CITY OF ROCKWALL  
205 West Rusk  
Rockwall, Texas

APPLICATION FOR ZONING CHANGE

SITE PLAN REVIEW

III. B. P&Z 87-35-Z/SP - Hold Public Hearing and Consider Approval of a Request from Scott Bowman for a Change in Zoning from "C" Commercial to "LI" Light Industrial on a 5.7 Acre Tract of Land Located on I-30 West of FM-549 and Approval of a Site Plan

○ SITE PLAN - PRELIMINARY  
 DOWNMAN METAL FABRICATION & SUPPLIES SCALE: 1" = 40'-0"

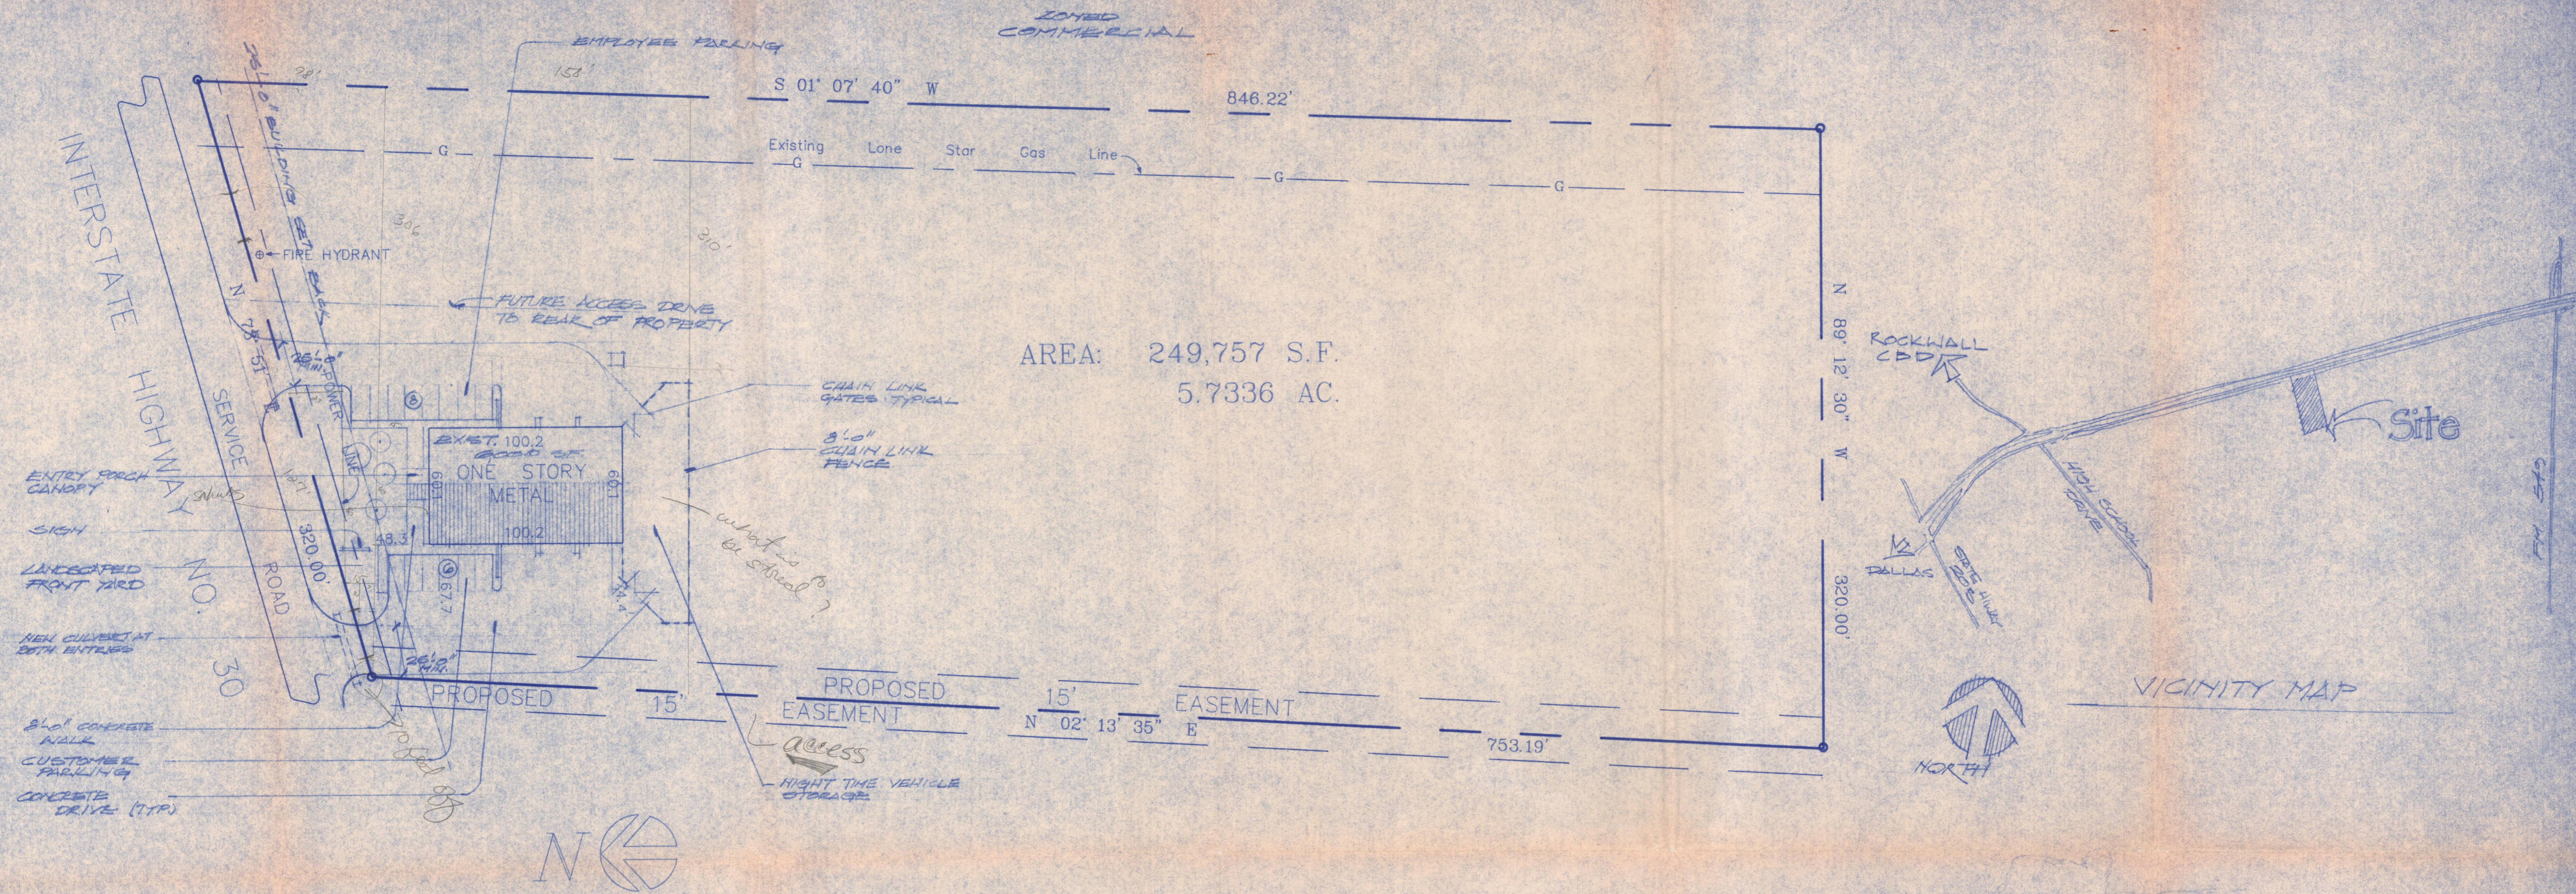
*existing buldy metal*

*need to check*

*need to check*

*what type*

*they are too close together*

*too close together*

Comments: *hasn't pick up name?*

- 1. Does plan conform to Thoroughfare Plan?
- 2. Do points of access align with adjacent ROW?
- 3. Are the points of access properly spaced?
- 4. Are street improvements required? *too close together*
- 5. Will escrowing of funds or construction of substandard roads be required?
- 6. Does plan conform with Flood Plain Regulations?
- 7. Is adequate fire protection present?
- 8. Are all utilities adequate?
- 9. Are adequate drainage facilities present?
- 10. Is there a facilities agreement on this site?

*total site landscaped  
 reqd - 12,488  
 total landscaped area = 43,658  
 road  
 channel  
 cost - 3327*

The site plan as submitted meets all of our requirements with the exception of a portion of the building exterior and the drive entrances. The building is a nonconforming building with a metal exterior. The building cannot be expanded without conforming to the current standards. However, it can be occupied as it is. Mr. Bowman is proposing to put up a brick veneer in the front and along the front 1/3 of the sides of the building. He also plans to build a brick entrance canopy to dress up the front. The drives as proposed do not meet our separation requirements of 200 feet. They are 127 feet apart. They are asking for a waiver to this requirement. They want to locate the center drive in the center of the property so that they can access the interior of their tract and still have some developable depth between the drive and the gas easement. The drive along the west property line would normally need to be 10 feet off of the property line. However, they are also proposing another future joint drive between this tract and the adjacent tract with the property line as the center. One joint drive in the future is more desirable than 2 drives that could be as little as 20 feet apart. I would like to see the access easement be made a requirement of the site plan.

- 1) providing an access easement at the west entrance
- 2) waiving the drive setback requirement on the west property line
- 3) waiving the drive separation requirements to allow a drive separation of not less than 127 feet.

1. Waiving a 200 ft. drive separation requirement
2. Waiving requirement for 10' separation of drive and side property line subject to the applicant obtaining an access easement for joint drive.
3. Allowing a minimum 127 foot separation between drives
